ADDENDUM NUMBER 1

PHASE I LEACHATE TREATMENT SYSTEM

**BRISTOL INTEGRATED SOLID WASTE MANAGEMENT FACILITY –
SOLID WASTE PERMIT #588**

PROCESS FLOW DIAGRAM

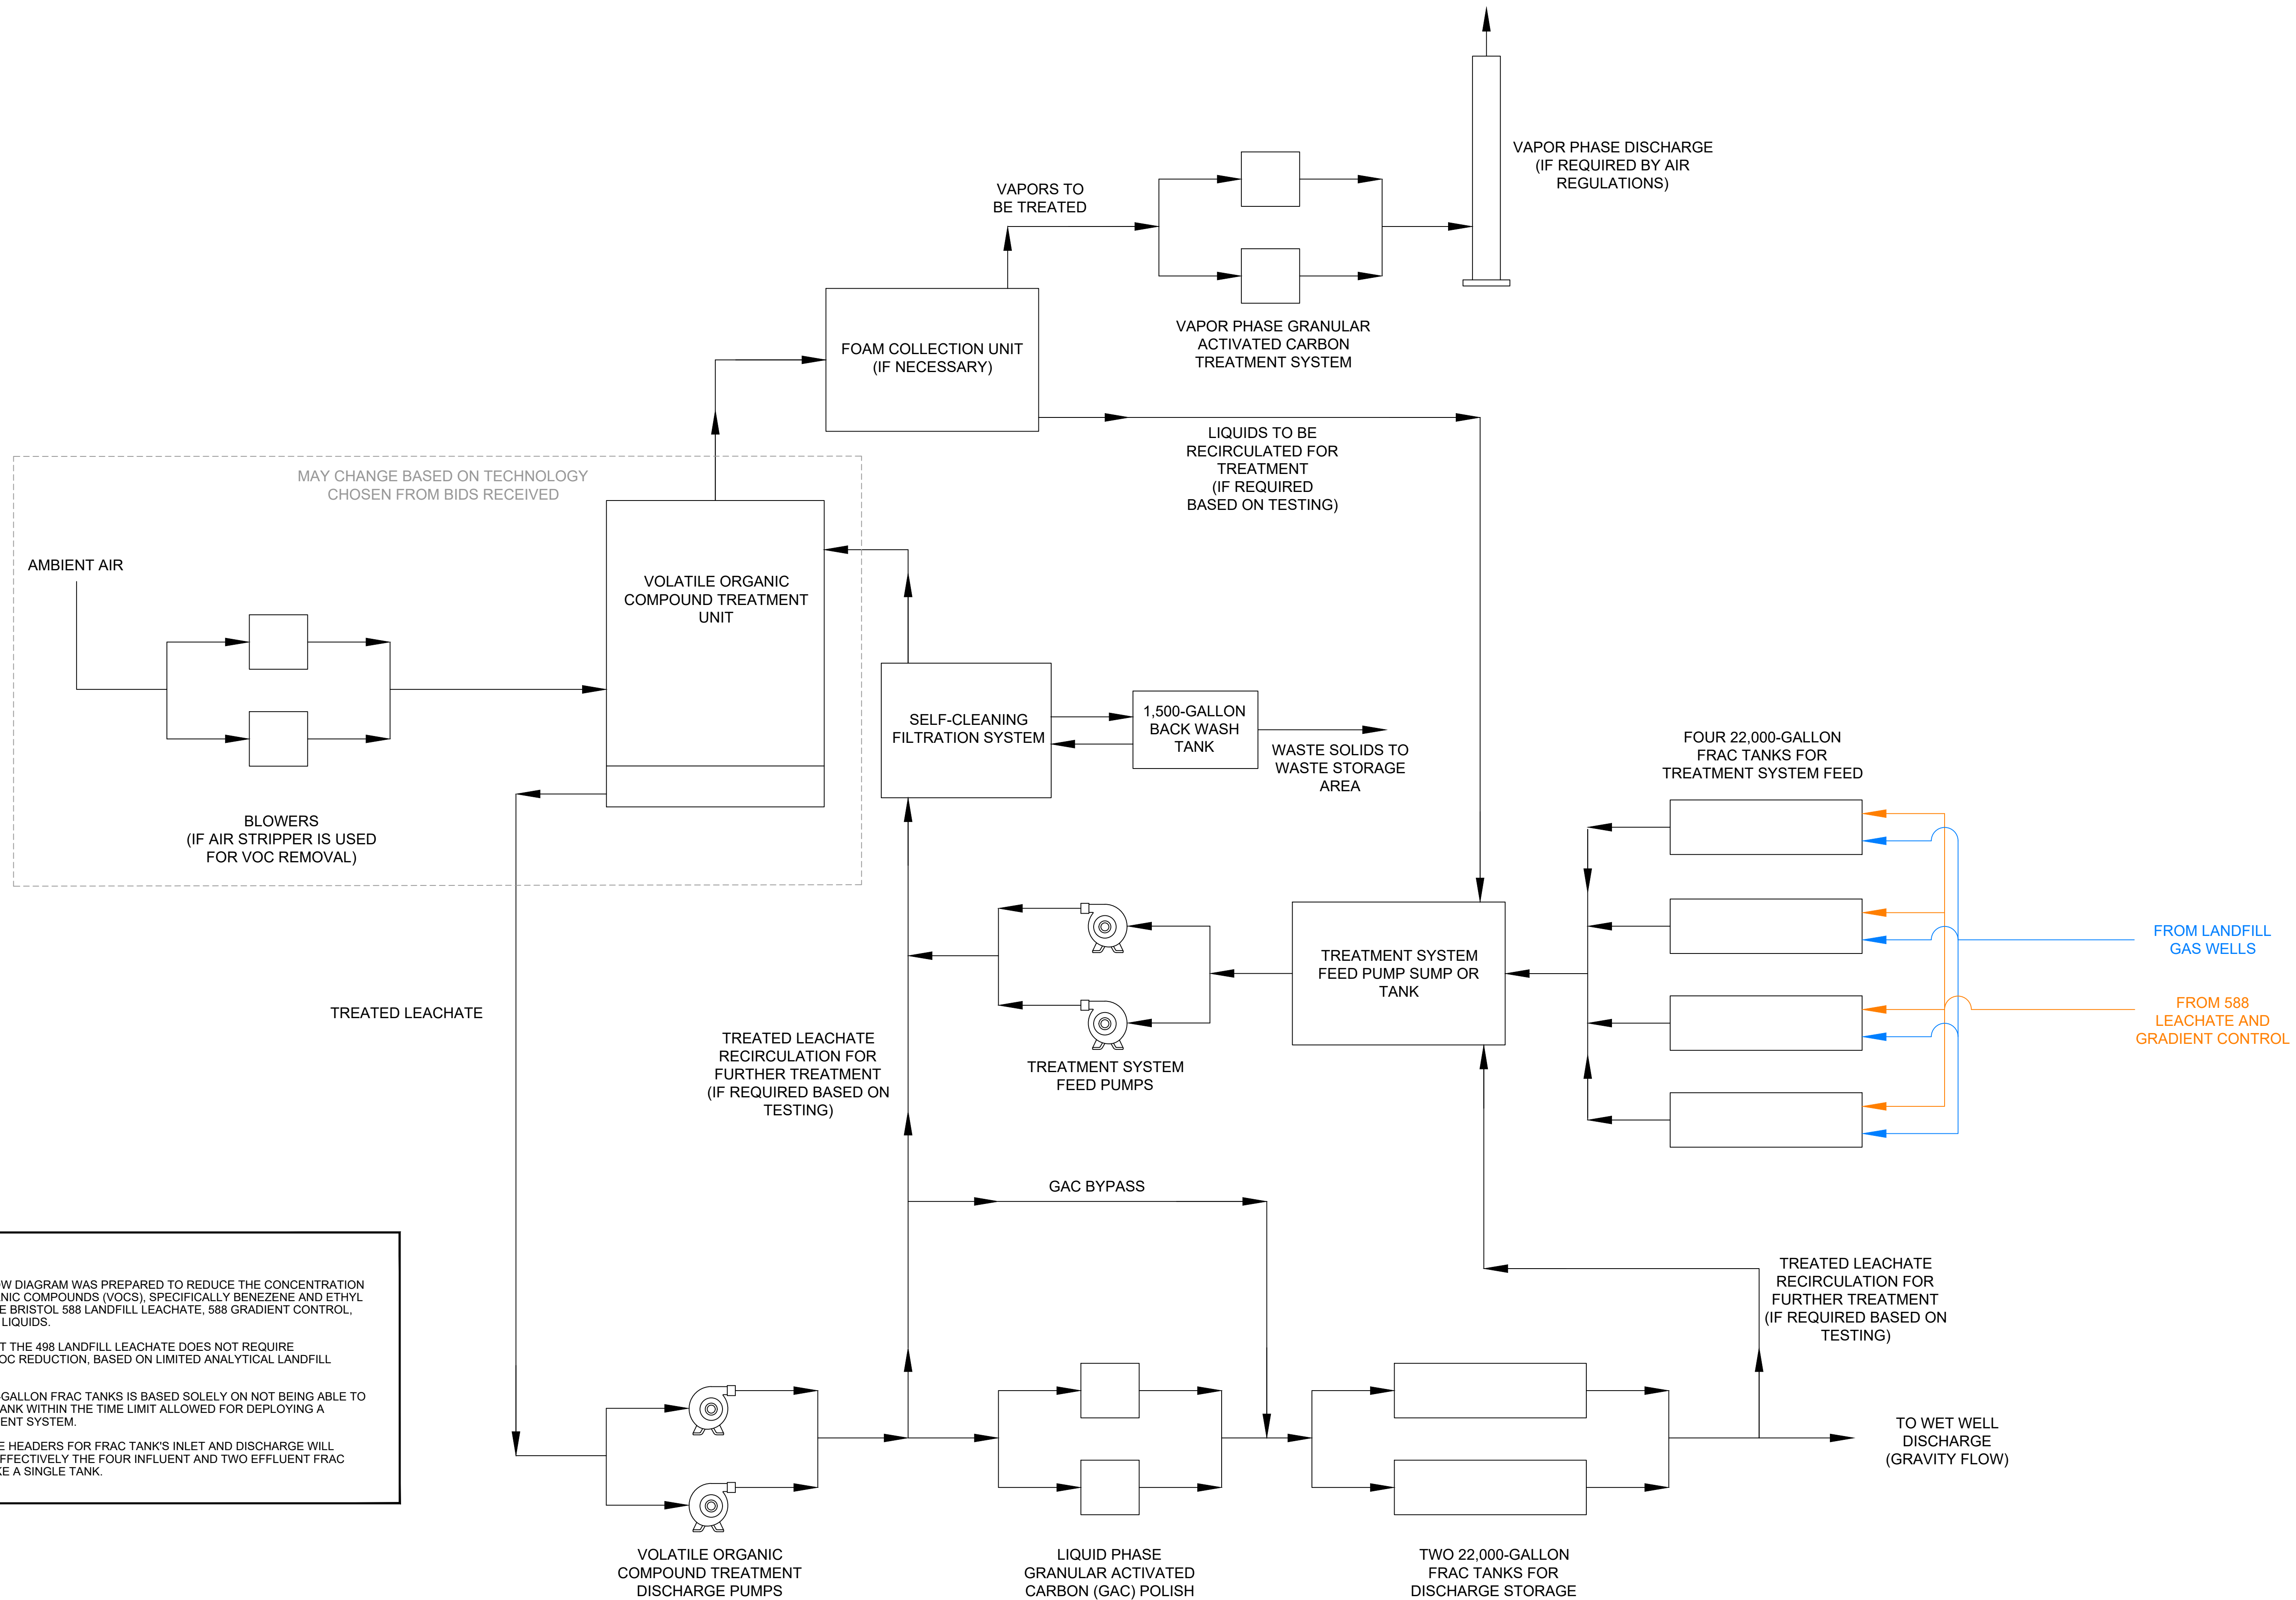
- The following changes were made to RFP No. SW-23-013 – Request for Proposals:
 - Process Flow Diagram (DRAFT) is being provided to show the conceptual process connections.
 - Inclusion of dual parallel vessels for liquid phase granular activated carbon (GAC) polishing step as part of what is required within RFP No. SW-23-013 for the leachate treatment equipment. If a liquid phase GAC polishing step is not necessary, based on the other equipment included in the equipment supplier’s treatment system, then a statement is required as to why the GAC polishing step is not needed. If the equipment supplier does not include the GAC polishing step in their base-bid then the equipment supplier shall include the GAC polishing step as an optional add-on to the proposed base-bid cost.
